From: Kobi Bradley [Kobi.Bradley@populous.com]
Sent: 10/26/2011 9:48:51 PM
To: Nicholson, Brian W. (Brian_Nicholson@baylor.edu) [Brian_Nicholson@baylor.edu]
CC: Earl Santee [earl.santee@populous.com]; Andrew Elmer [andrew.elmer@populous.com]; Jeff Spear [jeff.spear@populous.com]
Subject: revised site plan . connections
Attachments: SitePlan-question.jpg

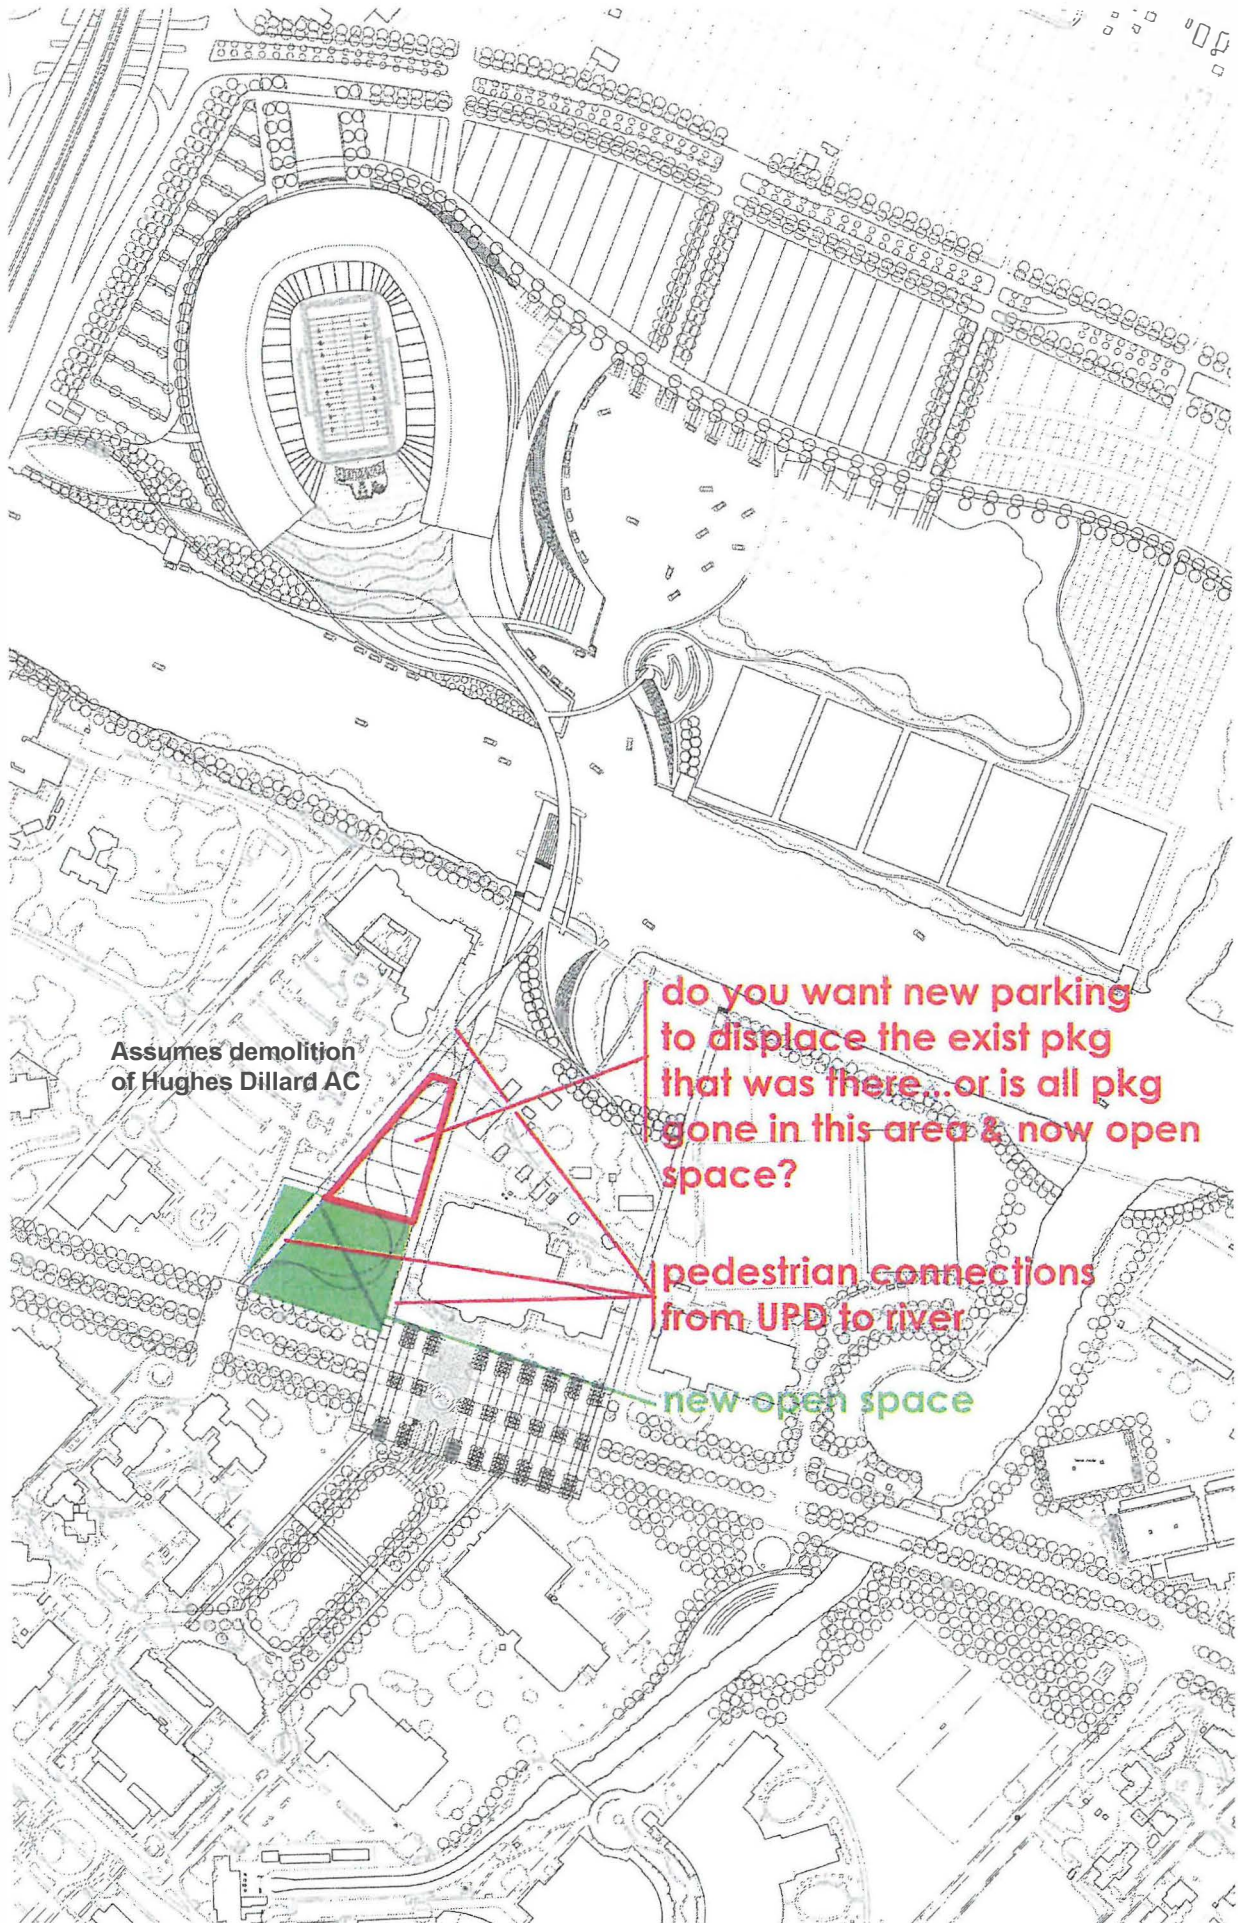
Take a look at this diagram and clarify my thinking for me. Do you want me to keep some parking in the area shown or nuke the lot that's there?

Assumes demolition
of Hughes Dillard AC

do you want new parking
to displace the exist pkg
that was there...or is all pkg
gone in this area & now open
space?

pedestrian connections
from UPD to river

new open space
